NSL-7724

Re: Application of Advance Energy Partners Hat Mesa for administrative approval of an unorthodox well location for its Dagger State Com 508H well in SW/4 NE/4 of Section 30, Township 21 South, Range 33 East N.M.P.M., Lea County, New Mexico.

WELL LOCATION AND ACREAGE DEDICATION PLAT

From: Lowe, Leonard, EMNRD
Sent: Monday, May 14, 2018 3:21 PM
To: 'bharris@advanceenergypartners.com'
Subject: NSL for Dagger State Com Well No. 508H

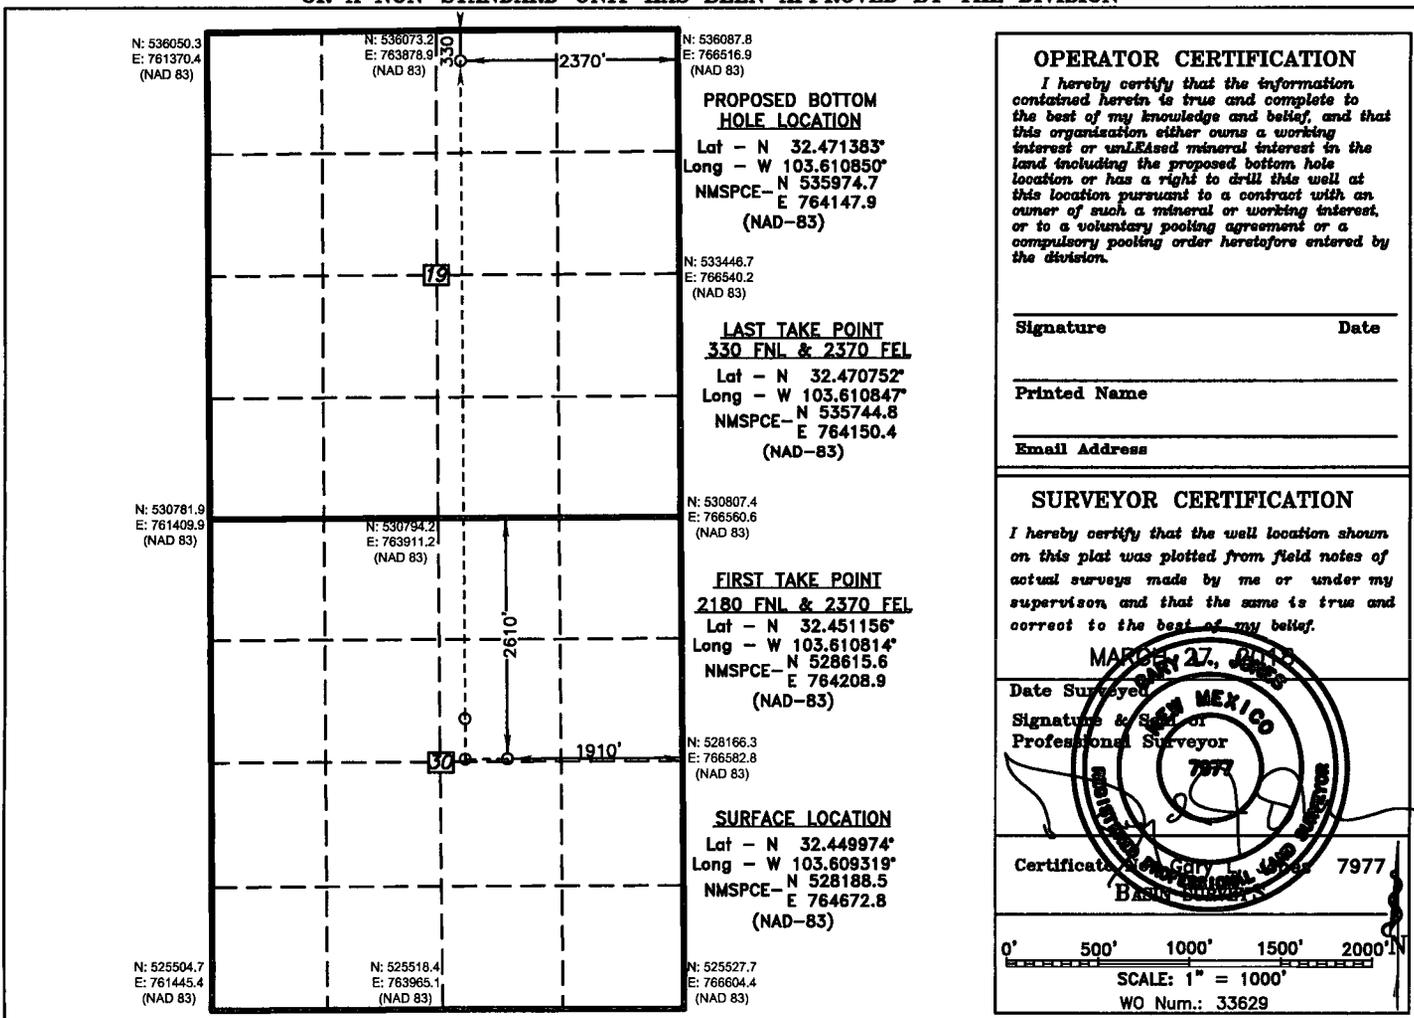
The second issue is that the permit for the 506H indicates the bottom hole footage is 100' from the north line of Section 19-21S-33E. We propose to drill approximately to 100' from the north line of Section 19 so we have sufficient hole to set and cement casing. The detail, however shown in the survey plat states the last take point is "330' FNL and 1510' FEL" Section 19-21S-33E. See the attached copy of the form C-102.

Our question is do we need to revise the form?

1. Your letter indicated, "Advance Energy Partners Hat Mesa is the operator of the spacing unit to the east." Your affected area is located to the West of your stated Project area. This project area affects the E2 W2 of Section 19 & the SE4 SW4 of Section 18. Was proper notice given? If not then this application is suspended until proper notice is given to all operators in all affected tracts. ✓

Due to the lack of public notice, your application is currently suspended until all proper notification is completed.

By email from you to our drilling manager, Braden Harris, you notified us that we were required to notified and request waivers from the offset lessee in the south portion of Section 18-T21S-R33E. The lessee is Ascent Energy and attached are letters from Ascent providing their waiver/non-objection for the subject wells.

This letter is to confirm the lease ownership in the following applicable leases listed on the attached Exhibit are common ownership. Advance Energy Partners Hat Mesa, LLC owns 95% working interest and Bullhead Energy, LLC owns 5%. In addition, Bullhead Energy, LLC has been notified of the well proposals and have consented to participate as to its 5% working interest.
